International Aero Engines

SERVICE BULLETIN

<u>OF REVISED OVERSPEED VALVE WITH INCREASED BYPASS FLOW - LUCAS FUEL SYSTEMS</u>
S.B.500-73-6968, 530-73-6968 - CATEGORY CODE 7 - MOD.ENG-73-0091

ENGINE - FUEL AND CONTROL - FUEL METERING UNIT - INTRODUCTION

Identification of Pre and Post CP6968 Assemblies Figure 1

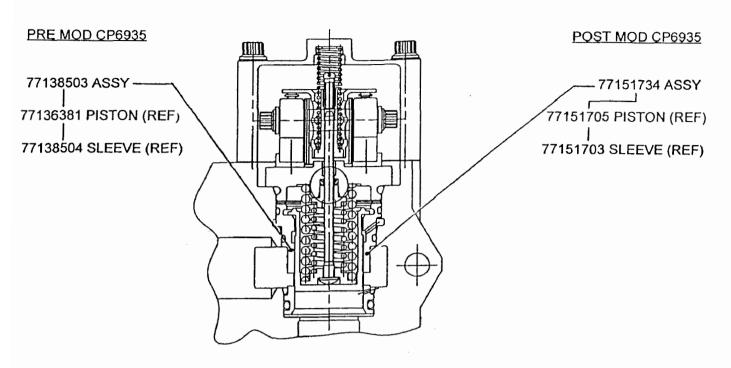
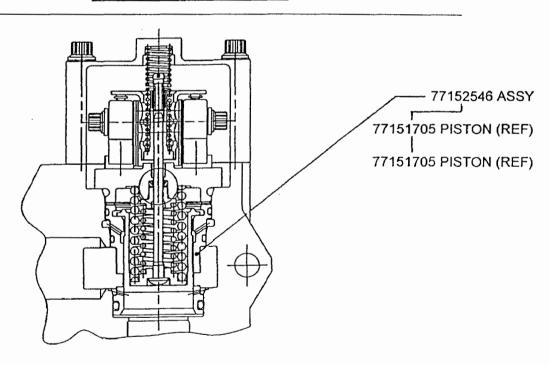
This Service Bulletin (Modification) is raised to introduce a revised overspeed valve piston and sleeve assembly.

The number of bypass holes in the overspeed valve sleeve has been increased from one to four. Each hole measures 1,23/1,20mm dia (0.0485/0.0475in dia) supplying a flow rate that will conform to the customer requirement of 850 to 1050 pph at operating temperatures of -50°C to 155°C.

The additional holes will reduce the possibility of complete blockage of the overspeed valve in the event of fuel contamination.

Assemble post CP6968 parts to the FMU in accordance with the CMM (1.K. References) and Figure 1 of this Service Bulletin.

NOTE: The overspeed valve piston and the overspeed valve sleeve are a mated assembly and must be retained as a set.
